Spokane Design Review Board

Wednesday, October 14, 2020

Board Briefing Session:

5:40 – 7:40	5) Albi Stadium – Recommendation Meeting	Taylor Berberich
	• Staff Report..... 15-20 m	
	• Applicant Presentation..... 25 m	
	• Public Comments and Board Q & A 25 m	
	• Board Discussion and Motion(s)..... 45 m

Figure 1. Existing bike routes to and through the site

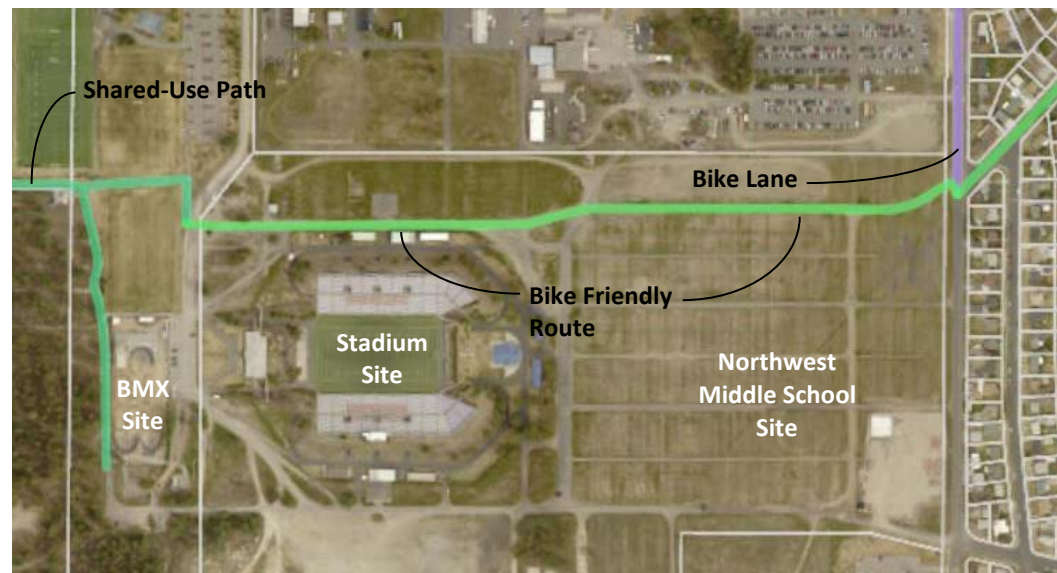
- As referenced in the shared-use path item above, Wellesley Avenue has an existing bike lane improvement that extends up to the east circulation road/Royal Court intersection. This bike lane connects to the existing bike-friendly route that runs along Royal Court to the south and north through the site along the existing vehicular drive. This route connects to the existing Shared-use Path on the Dwight Merkel Complex site. See Figures 1 and 2, below.

Applicant Response: The referenced bike route indicated is along an unimproved gravel path through the existing Albi parking lots and drive lanes. The project has maintained and substantially improved the existing condition for the community's use. The Albi Stadium project is improving the existing gravel path with a 12' paved "Shared-use Path", (see responses to aforementioned "Shared-use Path").

Figure 2. Approximate location of preferred Shared-use Path Alignment and Connection (Noted by red dashed line)

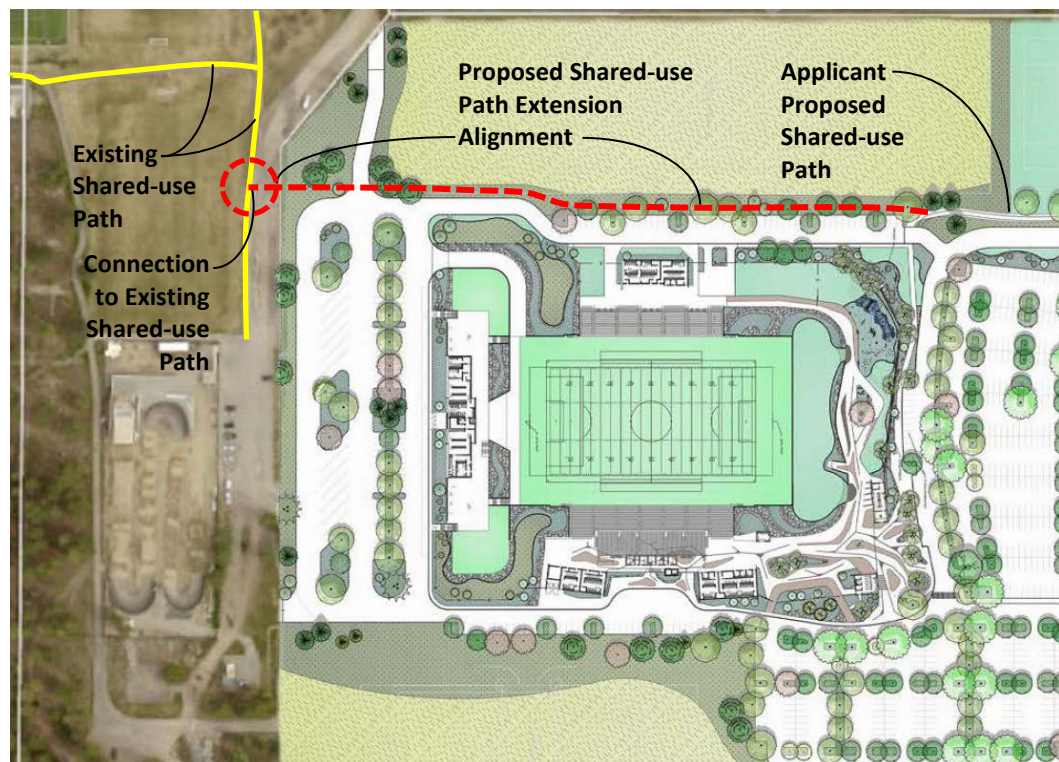
Further Staff Comments: Shared-use Paths cannot permit motorized vehicles. The co-use of a vehicular drive aisle is not permitted under current city policies.

Given these factors, does the Board find the proposed Shared-use Path alignment (with connection to the Shared-use Path on the Dwight Merkel site) satisfactory?

STADIUM PLAN

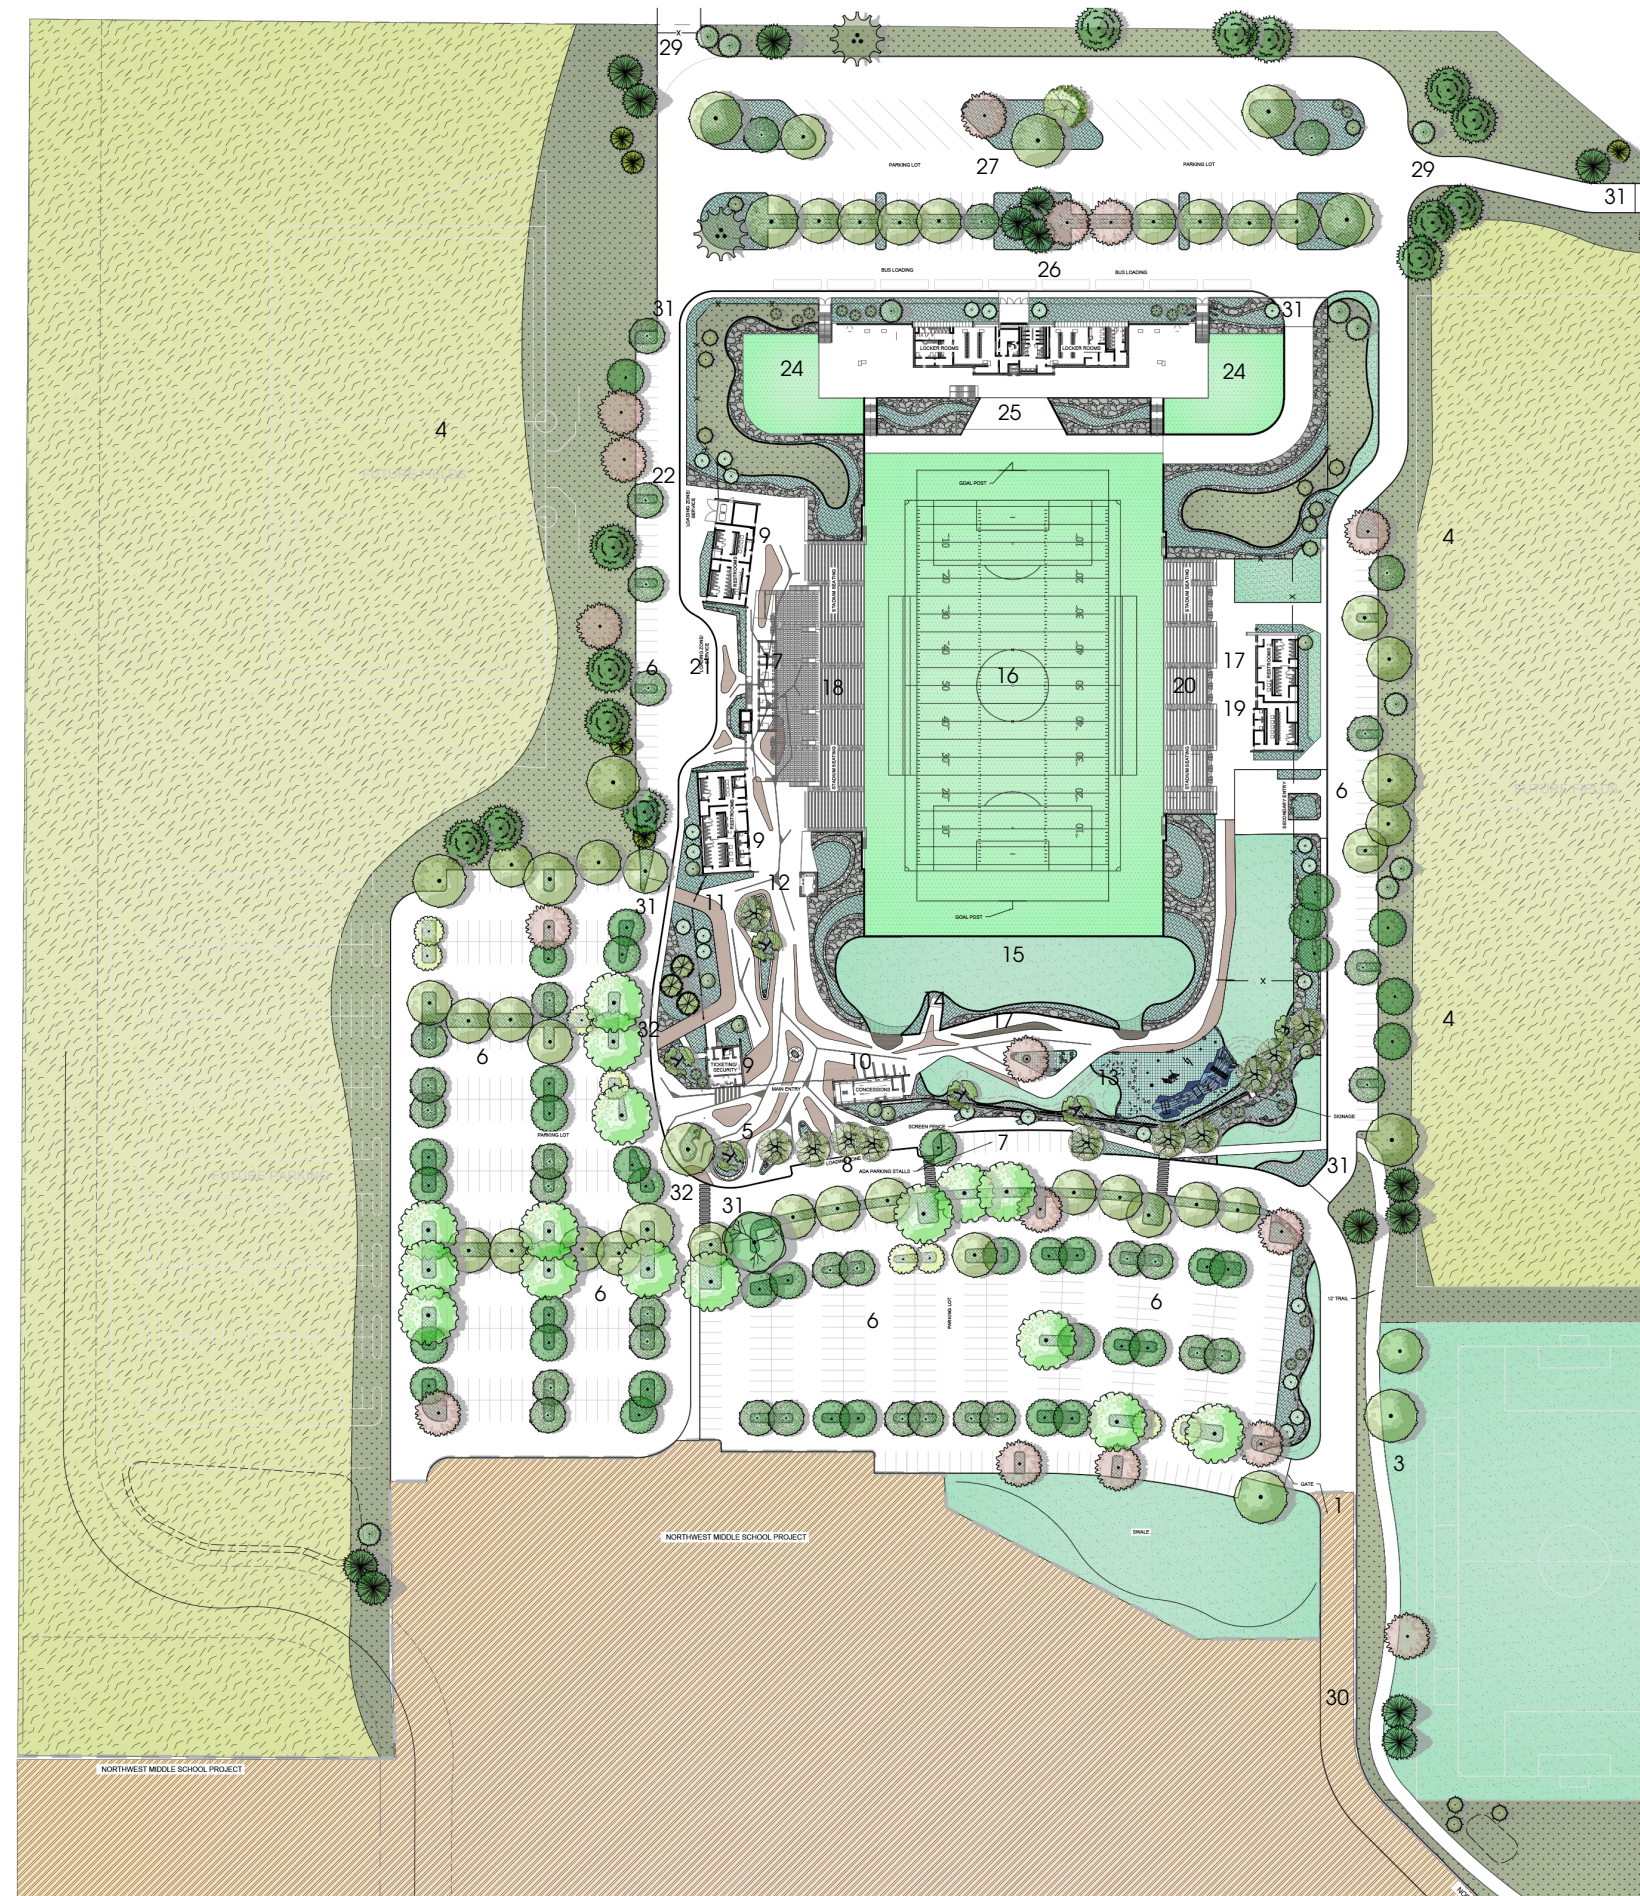
- 3. The Applicants shall provide additional details on managing traffic circulation through the site (via gates, etc.) for varying operations and provide details to the Board at the Recommendation Meeting.**

4. It has been noted that while the proposed surface parking lots do have landscaping, they do not provide adequate safe pedestrian connections through the parking lots that comply with [SMC 17C.110.540 Pedestrian Connections in Parking Lots](#) (see Figure 3). Unless the Applicant is requesting a Design Departure from these Design Standards, does the Board have any compliance advice to offer?

Gates are provided as indicated in the "Stadium Site Plan" as Legend Item 31. The purpose of these gates is to control vehicle access to parking lots based on parking needs for a given event; allowing the Owner to minimize parking lots used for a low attendance event and conversely limiting the amount of cleaning required after an event. The access gates also allow the Owner to control vehicle access from spectator parking and that of event personnel and participant parking areas. Gates on fire department access routes will be provided with Knox Boxes for access. None of these gates impede pedestrian or multi-modal access.

Applicant Response: The Design team has added two additional cross walks from the southern parking lot to provide additional pedestrian crossing routes. ADA parking is provided adjacent to the main entry plaza as is paratransit and general public drop-off. This drop-off area will slow vehicle traffic after and in front of the two primary pedestrian crosswalks. The main parking lots are provided with exiting that allows for discharge of vehicles at the conclusion of an event to be away from the pedestrians exiting the facility.
